Rezoning Transportation Analysis

Petition Number 2016-030

Location Approximately 5 acres located on the southside of Mockingbird Lane between Park Road and Hedgemore Drive.

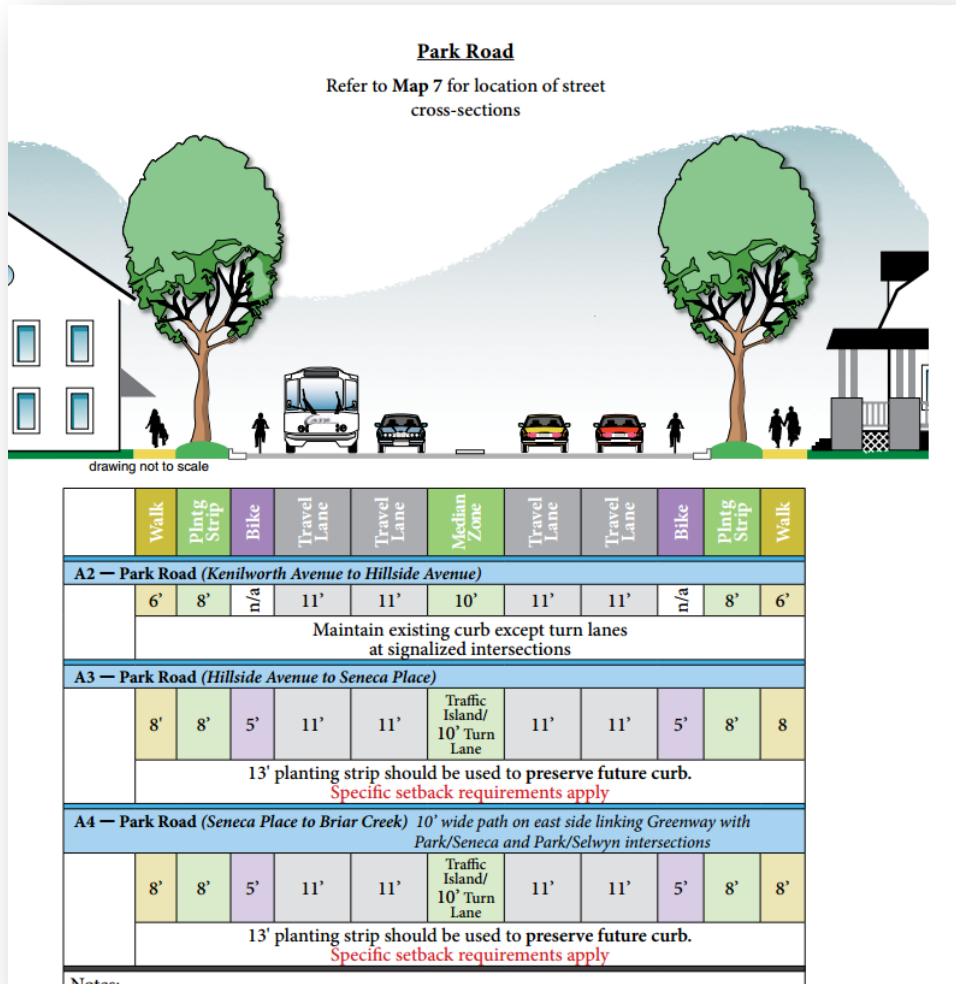
1. The setback should be measured from the back of the future curbline, which is measured 34.5' from centerline of the existing roadway per the Park Woodlawn Area Plan. See below:
